RFB-2022-20
PRINCETOWN SHERIFF'S SUBSTATION RENOVATIONS & NEW CONSTRUCTION
C2 DESIGN GROUP

ADDENDUM #2

Issued Date: 03/04/2022

1
A101-S First Floor Plan
SCALE: 1/4" = 1'-0"

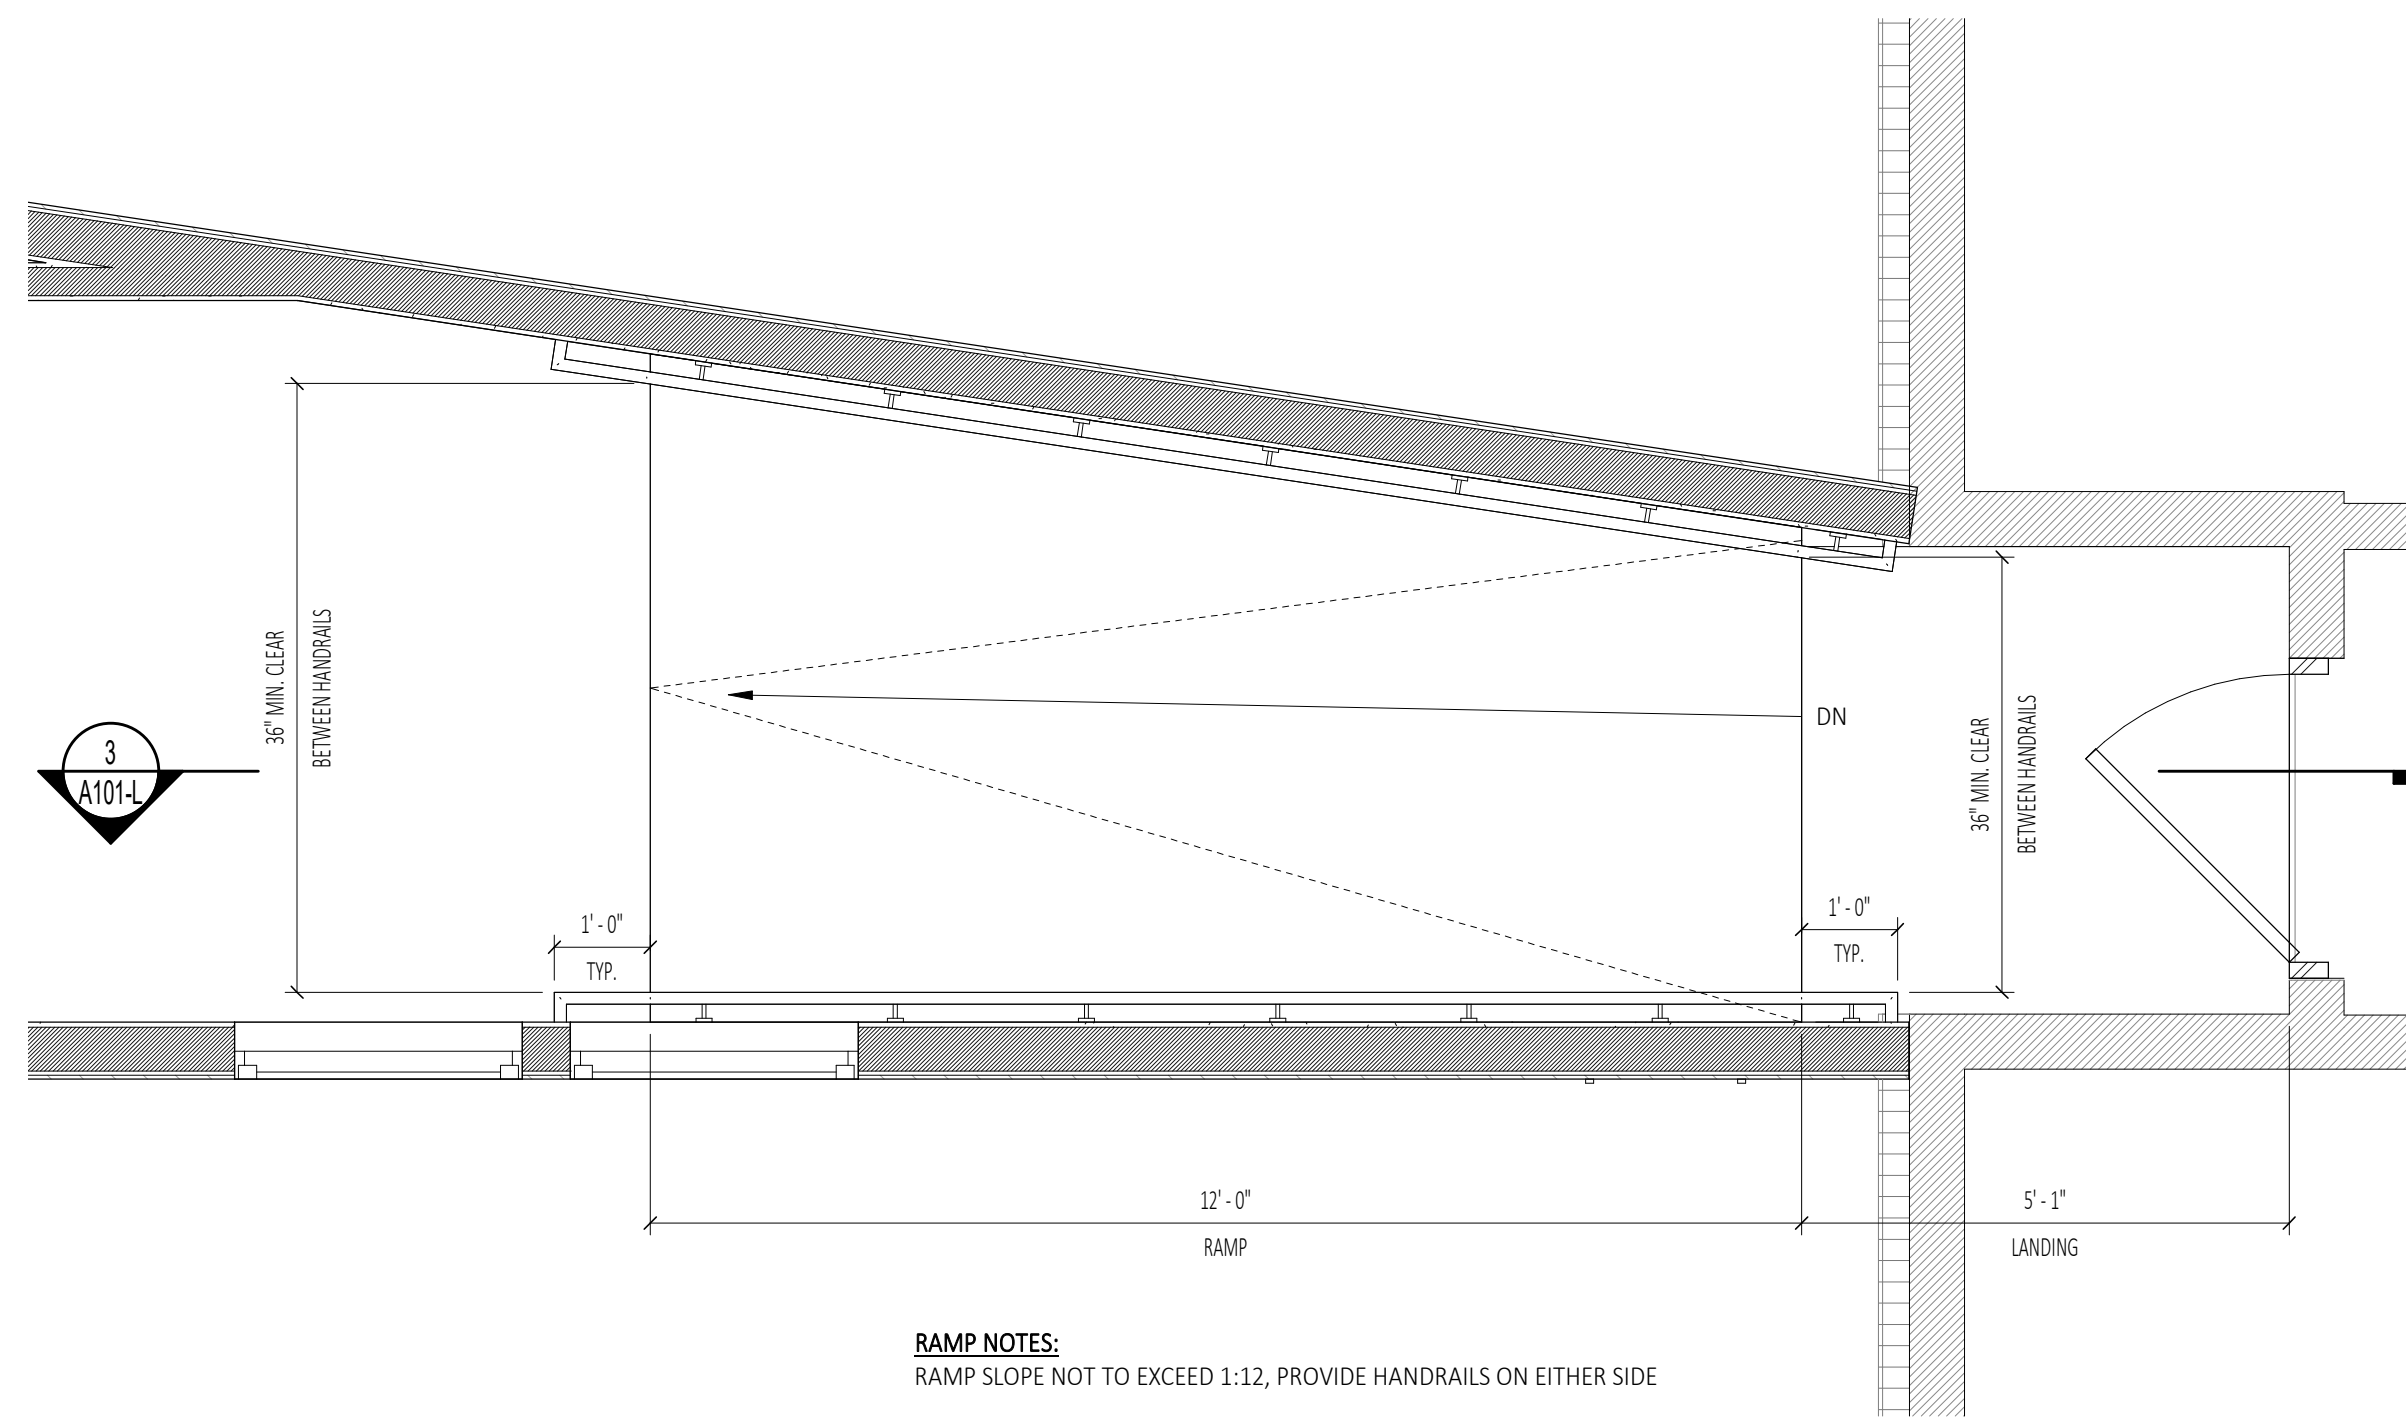
On drawing D100-S in room 119 Family, there appears to be (2) existing counters (both next to the existing half walls), however on drawing A101-S one is labeled with footnote 109 (as an existing counter) while the other is labeled with footnote 106, is a new counter to be installed to replace the existing one?

On drawing A101-S, footnote 108 references a drawing A601-S. Is this the correct drawing to reference? It was not included with the other drawings.

Both counters are existing to remain (Note #109). The drawings have been revised accordingly.

The sheet number in note #108 is incorrect, see sheet A600-S to reference the required details. The sheet number in keynote #108 has been revised on sheet A101-S

1 Floor Plan
A101-L SCALE: 1/4" = 1'-0"

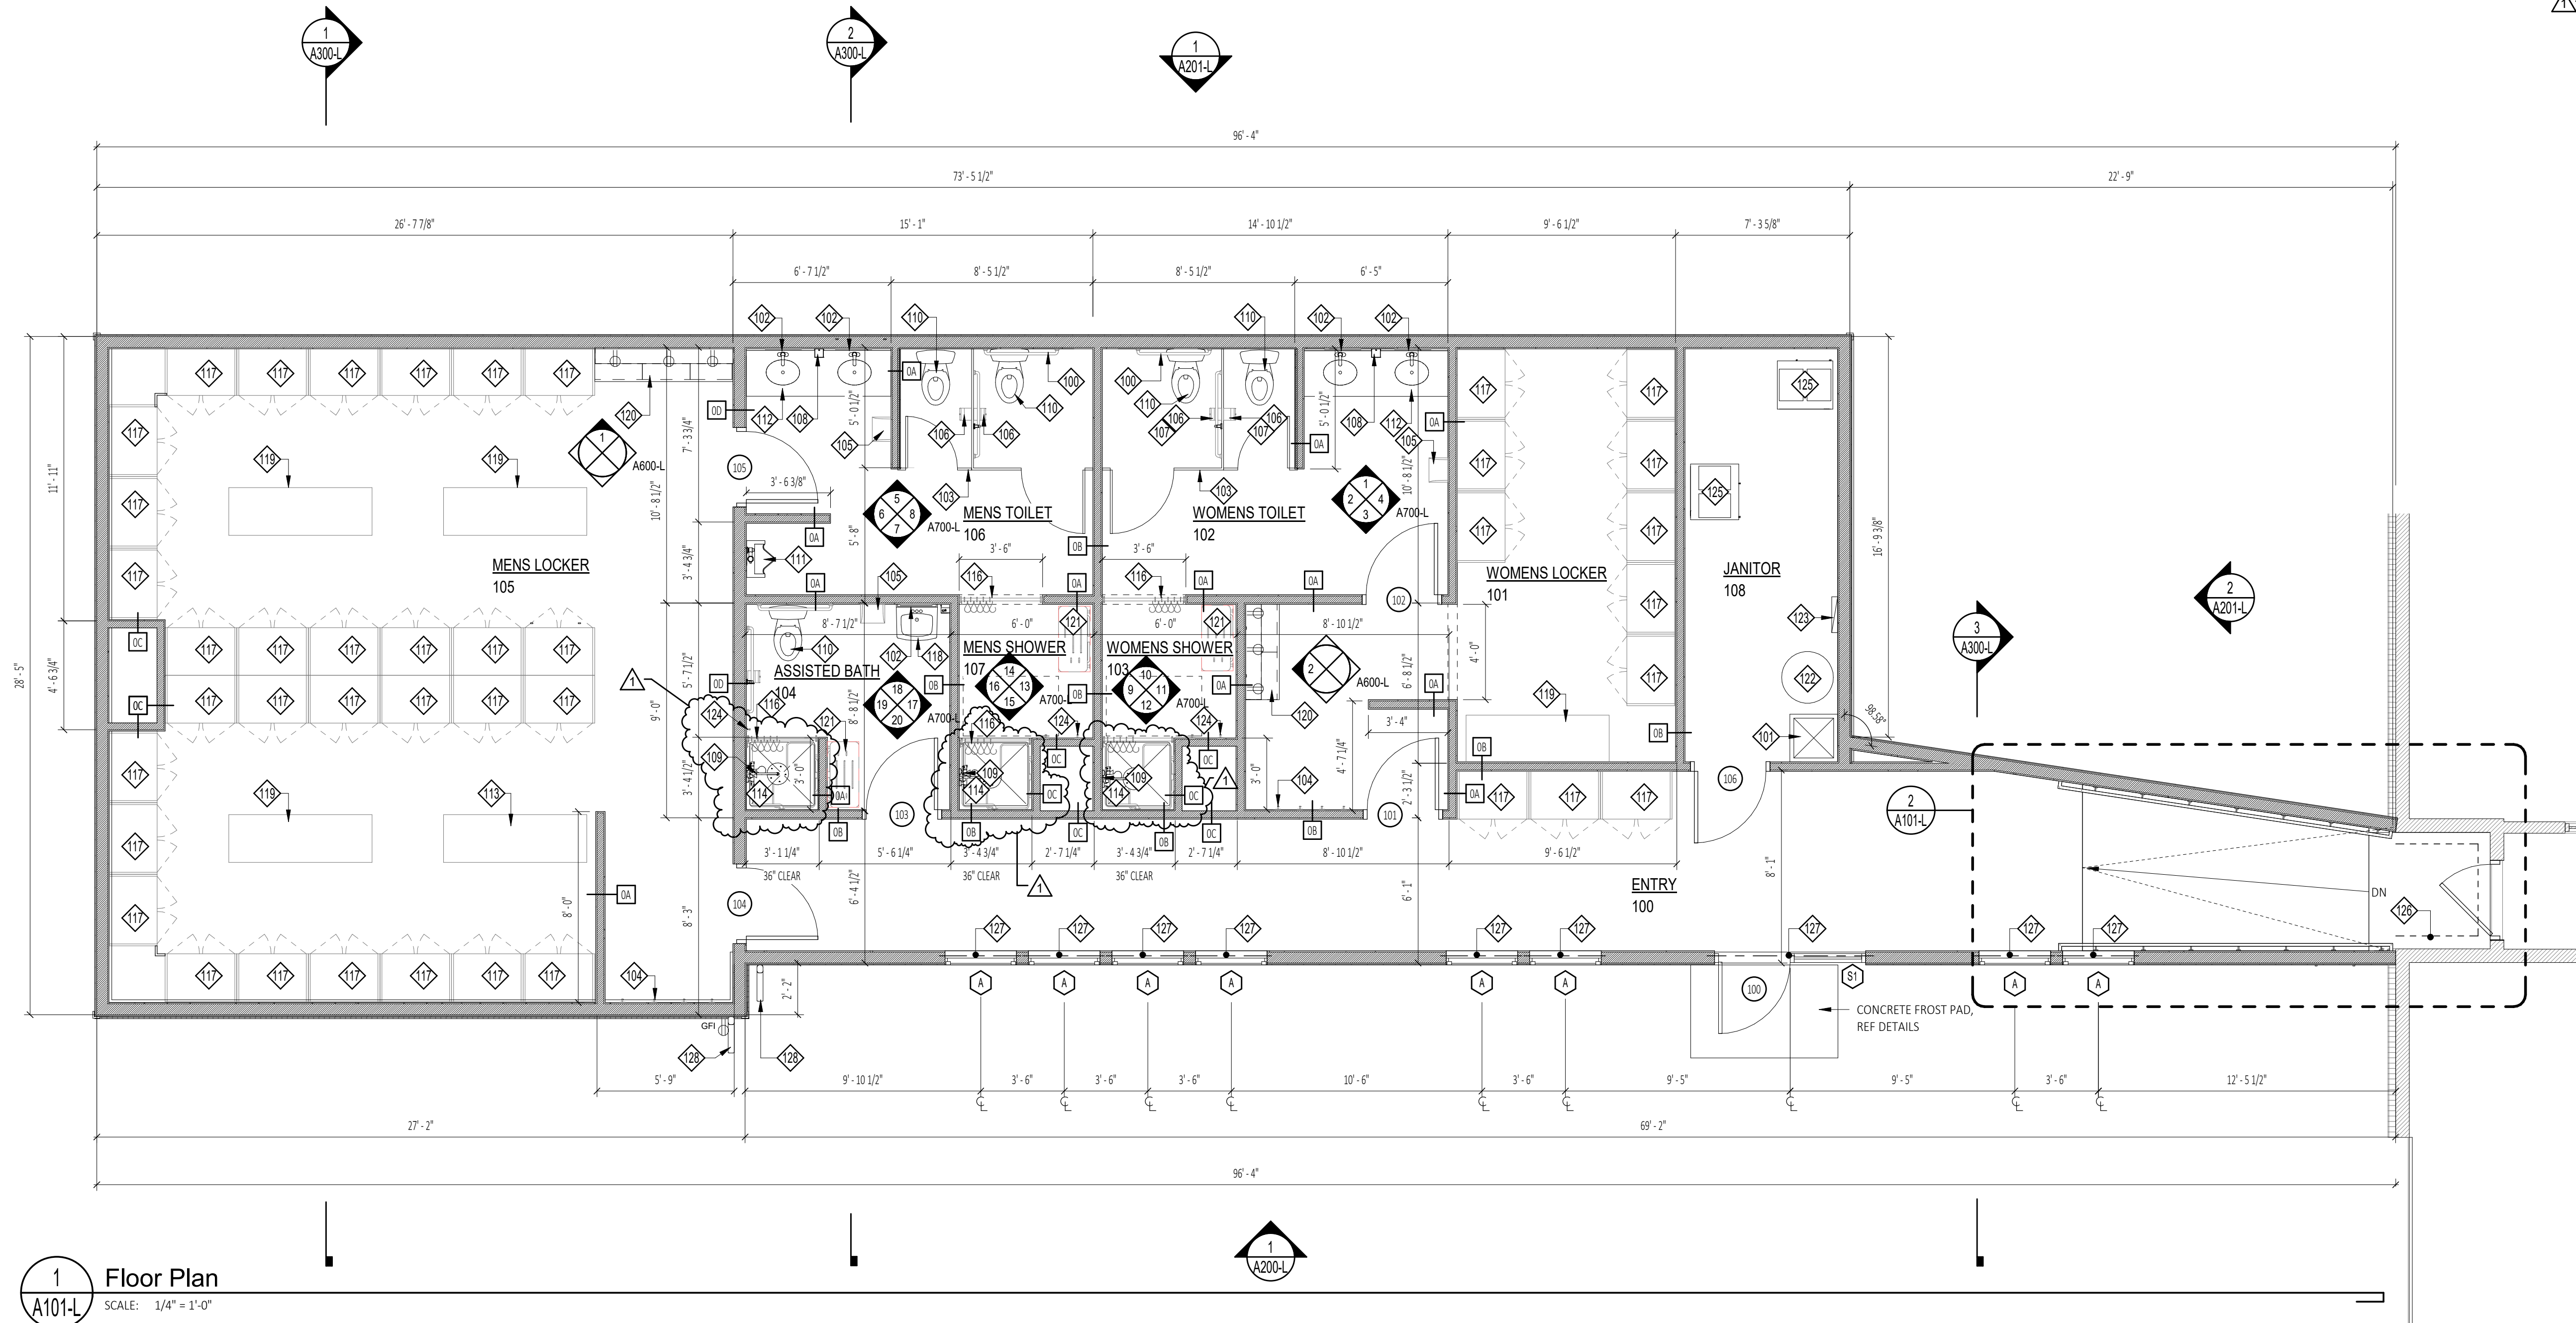
Is there a header schedule? Window section detail shows 2x6. Note 127 says 2x10. No note at interior doors

There is no header schedule. The header sizes are called out on the floor plan A101-L per note 127 as 2x10 headers. The window section details on A900-L says "scheduled header". Interior door headers shall be based on best practice unless noted otherwise.

Provide robe hook in assistive toilet room. See keynote 124 on A101-L and keynote 711 on A700-L on revised drawings for location.

1 Roof Framing Plan
SCALE: 1/4" = 1'-0"

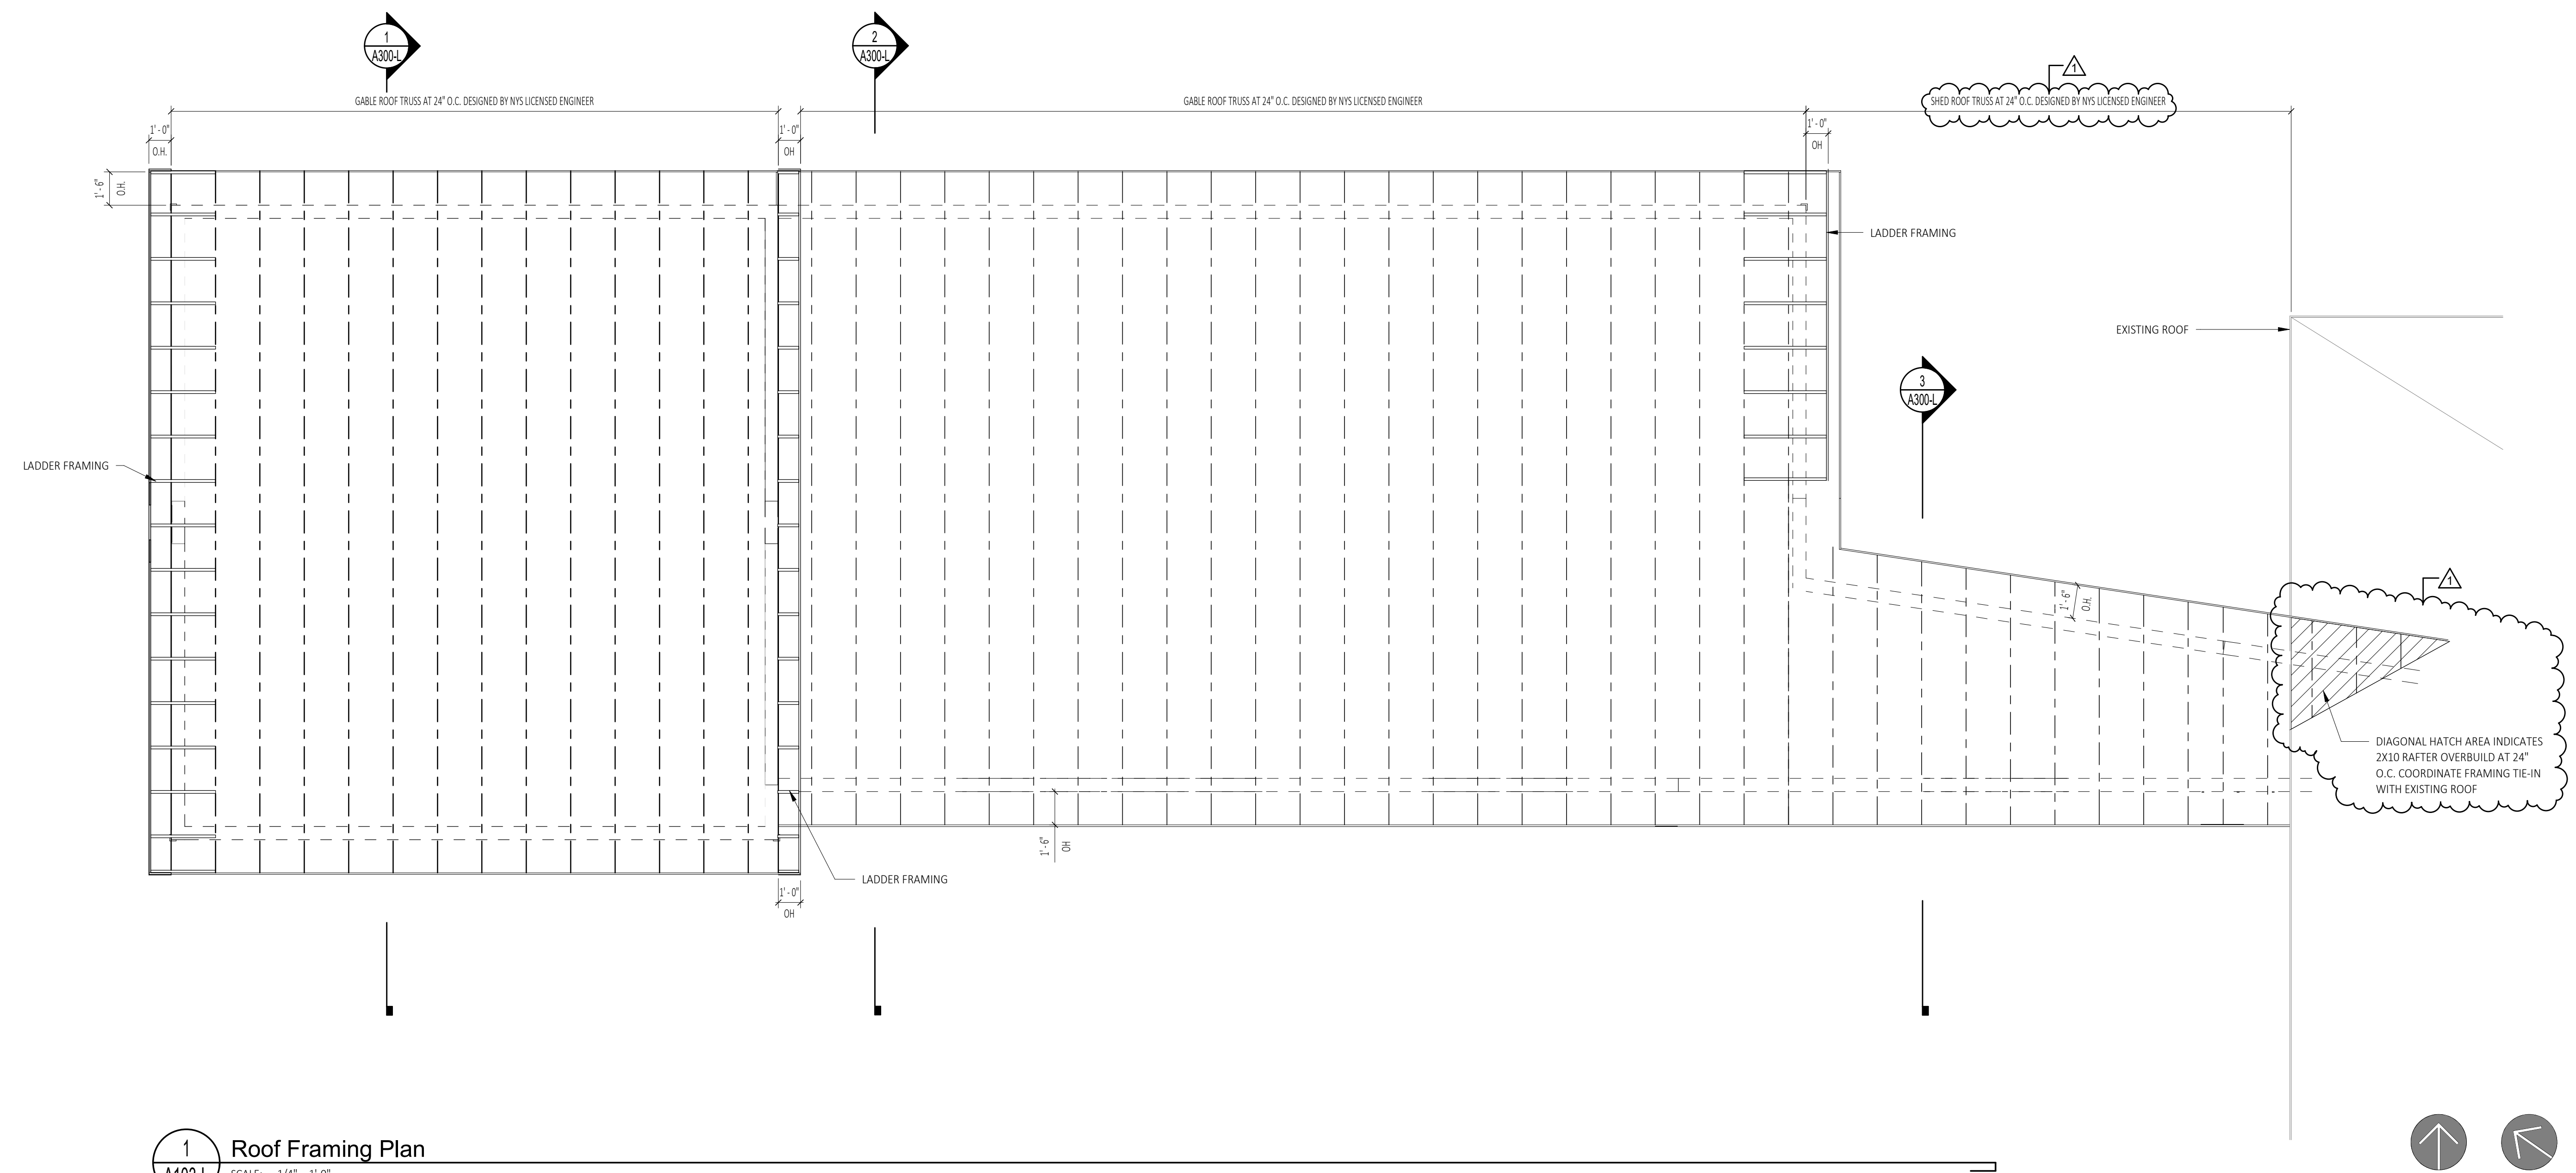
Confirm "shed" roof at Locker Addition connector is stick built with 2x10 rafters. Plan drawings indicate trusses, section shows 2x6 rafters.

Shed roof at Locker Addition connector is to be trusses at 24" O.C. Provide 2x10 rafter overbuild to connect to existing roof as indicated on A103-L. The roof framing plan on A103-L and section 3/A300-L has been revised to clarify.
